Comment Date: January 27, 2012 16:38:15PM
Supplement to the Draft Solar PEIS
Comment ID: SEDDSupp20140

Re: Comments of enXco, Inc. on the Supplement to the Draft Solar Programmatic Environmental Impact Statement

Figure 3: Probability of Tortoise Occurrence near Soda Mountain Solar Project Area

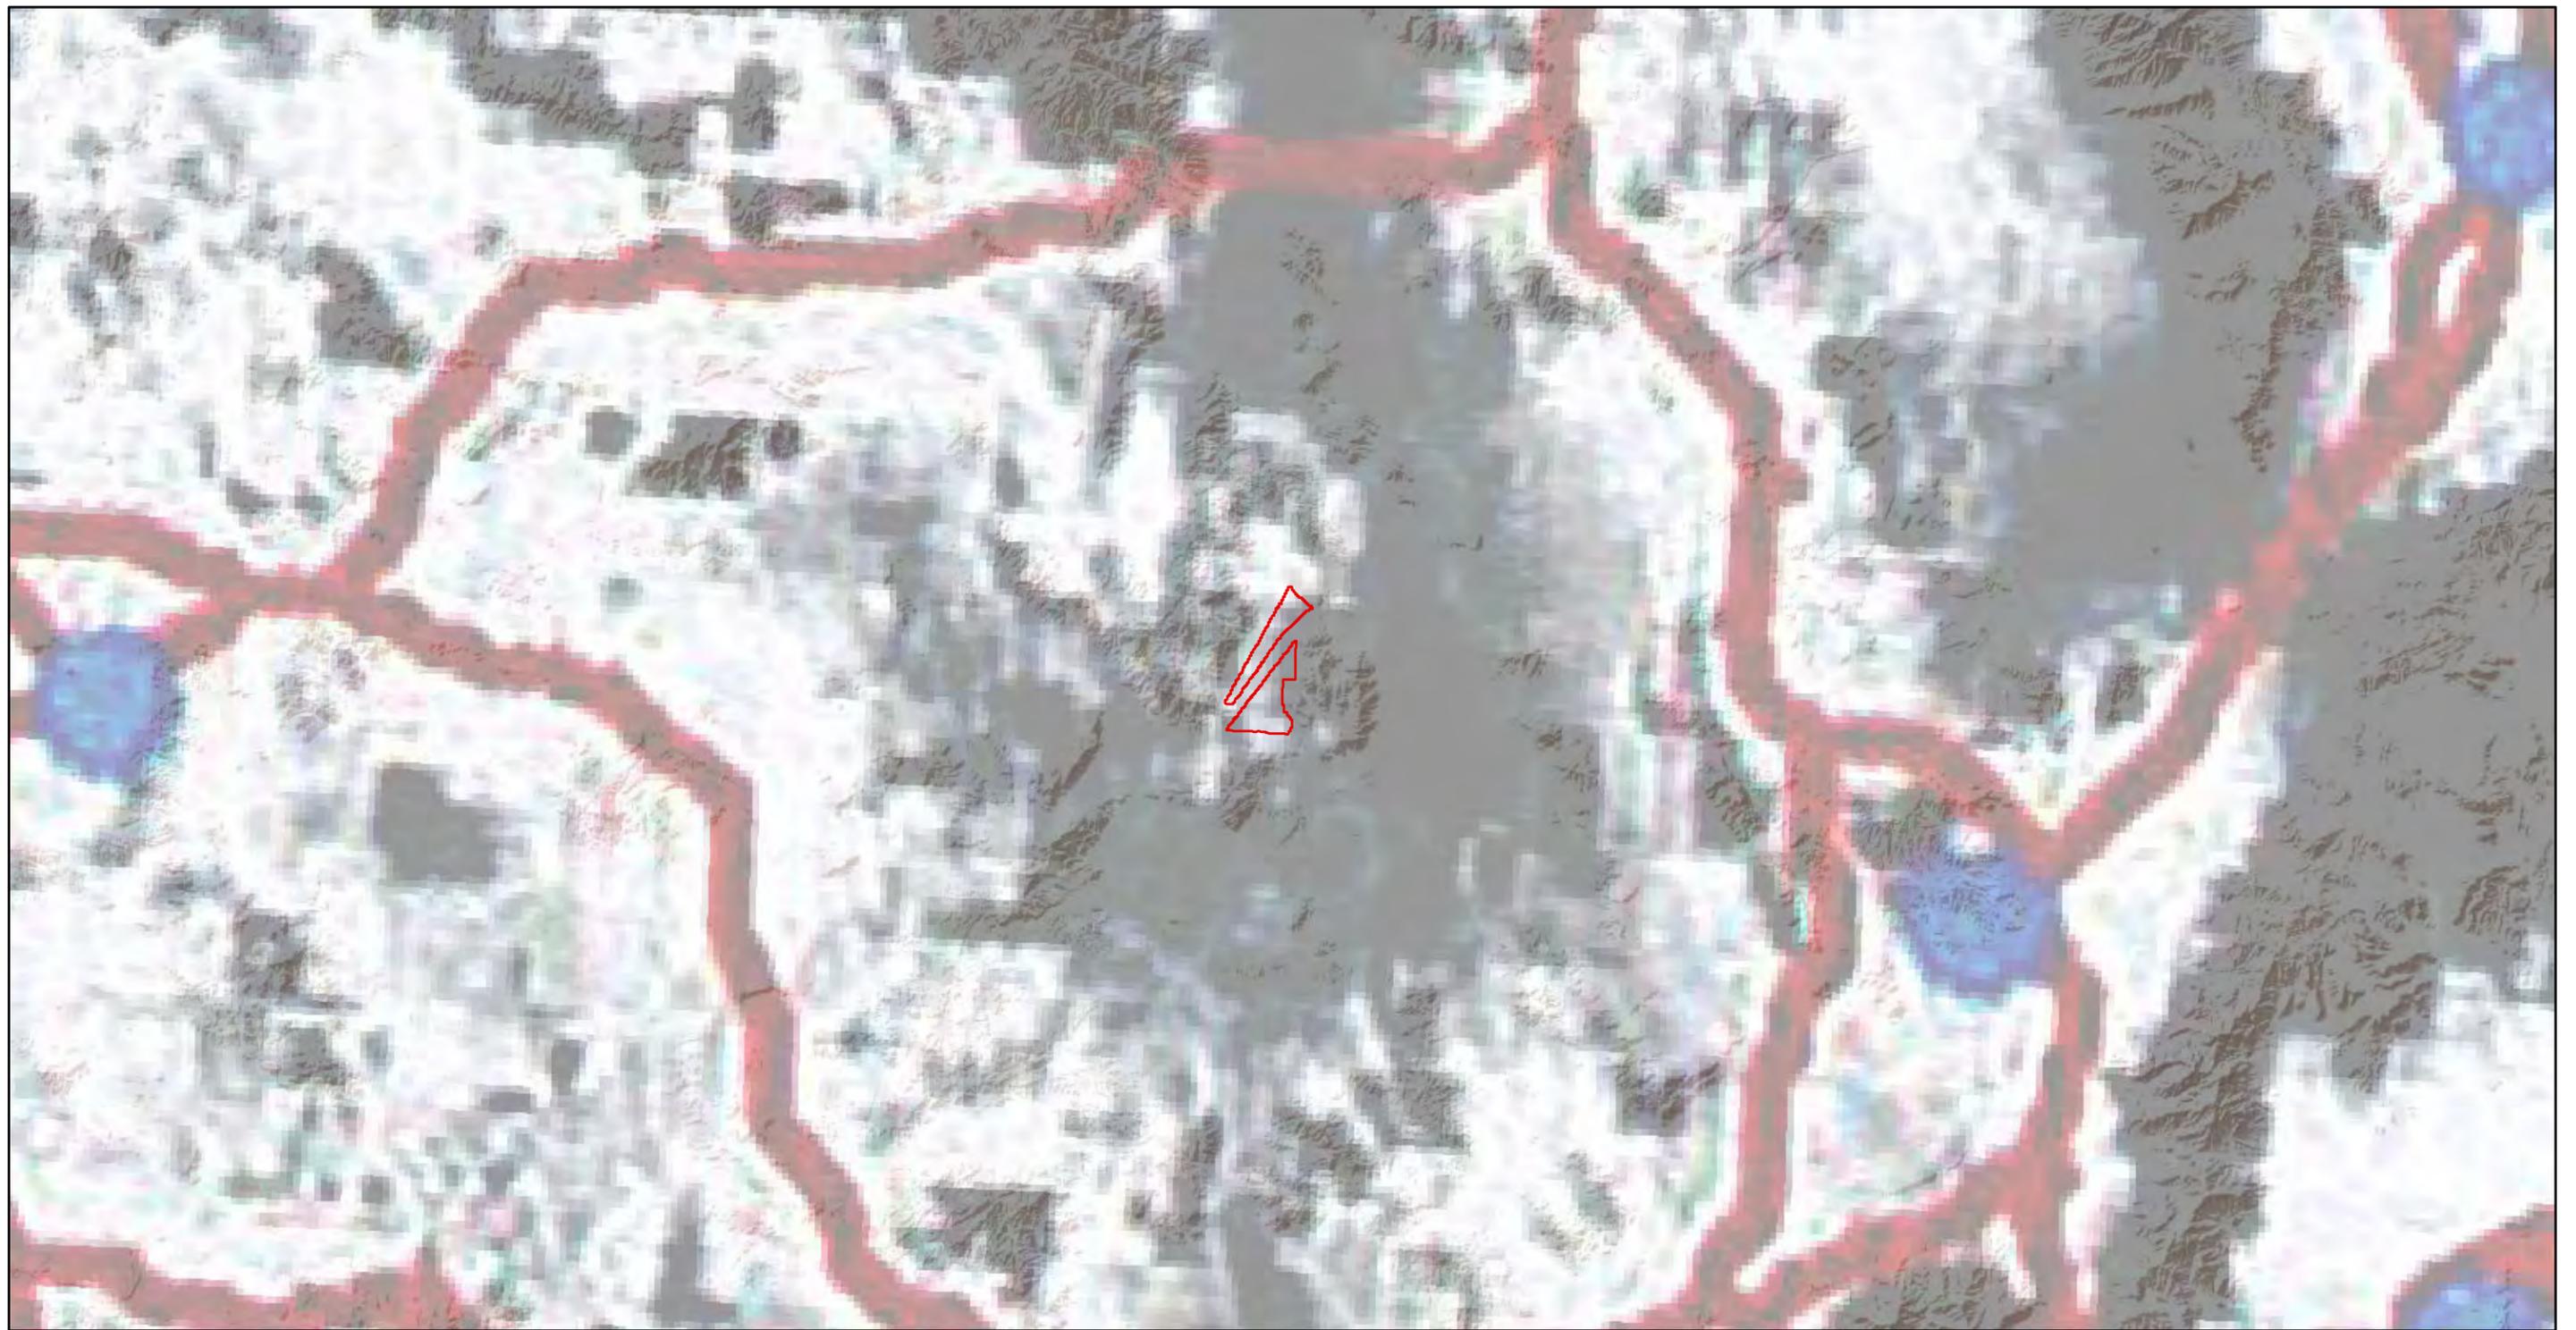
A recent National Park Service article (Hagerty and Tracy 2011) corroborates this conclusion with a genetic study determining that the Soda Mountains and Baker Sink serve as effective barriers to desert tortoise migration and indicating that the area around the Soda Mountain Solar Project site has a low probability of tortoise occurrence, with likely connectivity pathways located well north, east, south and west of the Soda Mountain Solar Project site (Figure 3).

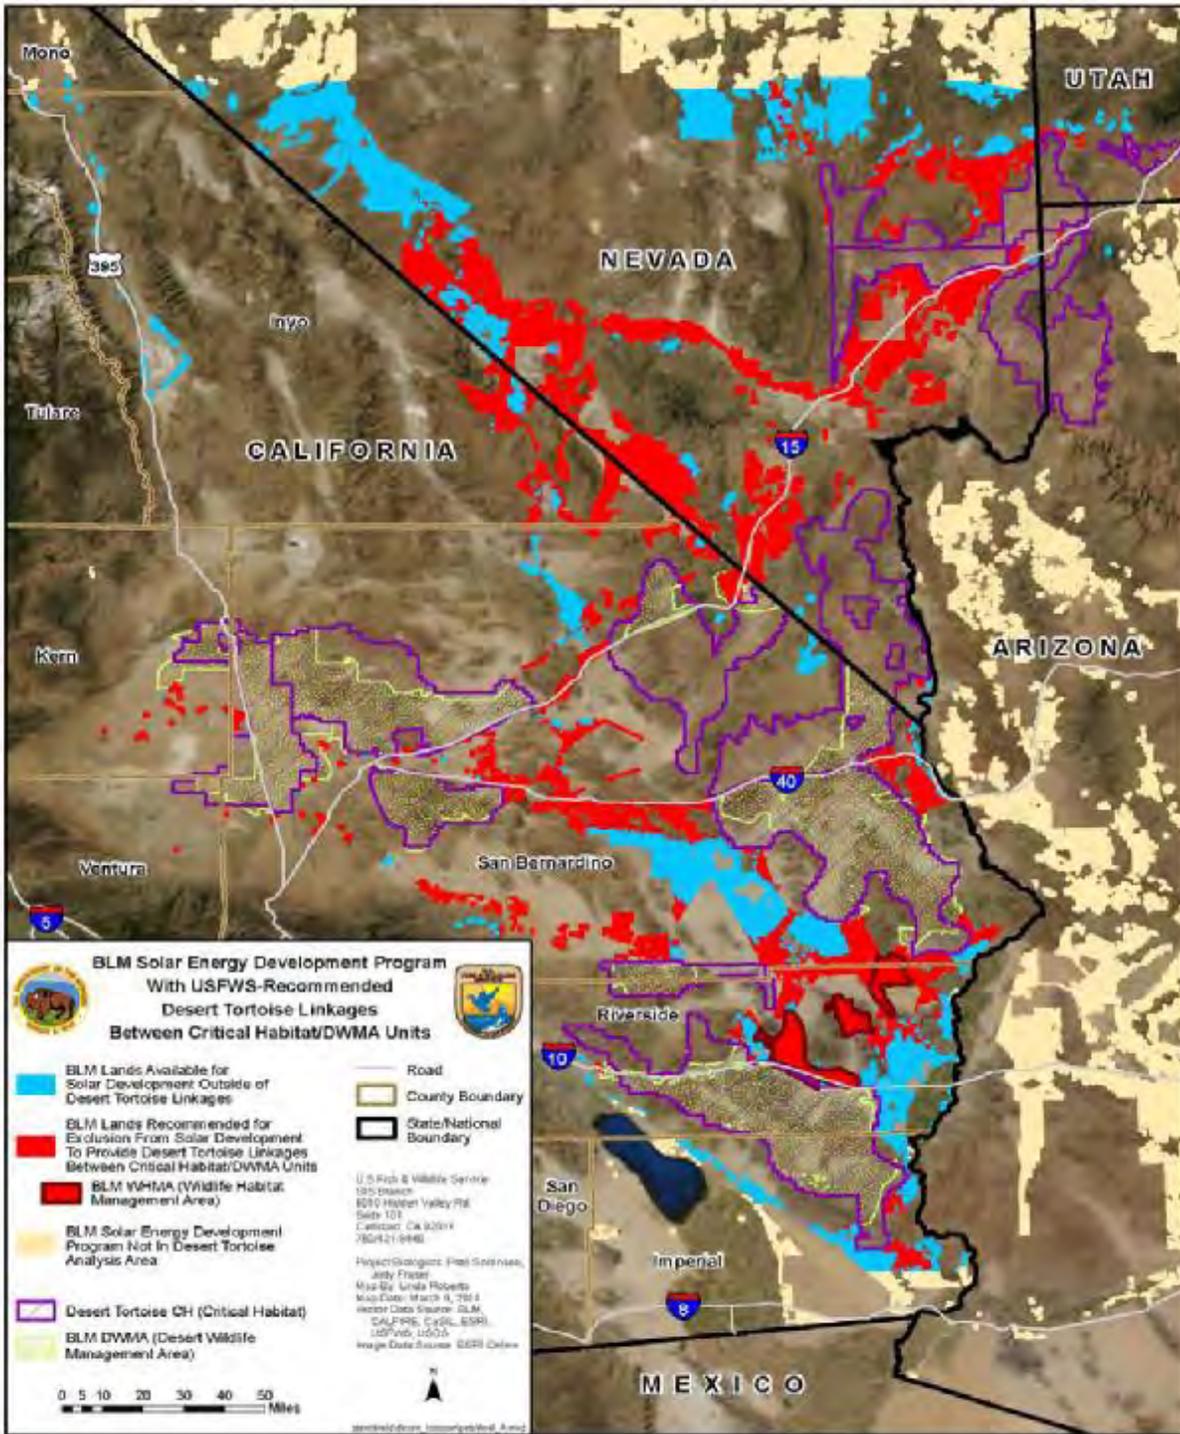
Comment on Connectivity or Linkage Habitats. The basis for BLM’s proposed connectivity habitats was not provided. Thus, it is not possible at this time to provide a complete analysis of the adequacy of the impact minimization provisions. We strongly recommend that BLM’s proposed connectivity habitats shown on Figure 2.2-2 be replaced with connectivity or linkage habitats recommended by the FWS in their comments on the Draft PEIS for Solar Energy Development, dated May 6, 2011, and that their recommendations be adopted in the final version of the habitat connectivity map in the Final EIS. Their recommendation is contained on Figure B-2 in the form of a map and narrative. We include it in our comments as Appendix 2. It is important to understand that their recommendations identified lands to be included in a “...minimum linkage design necessary for the conservation and recovery of the Mojave population of the desert tortoise....”
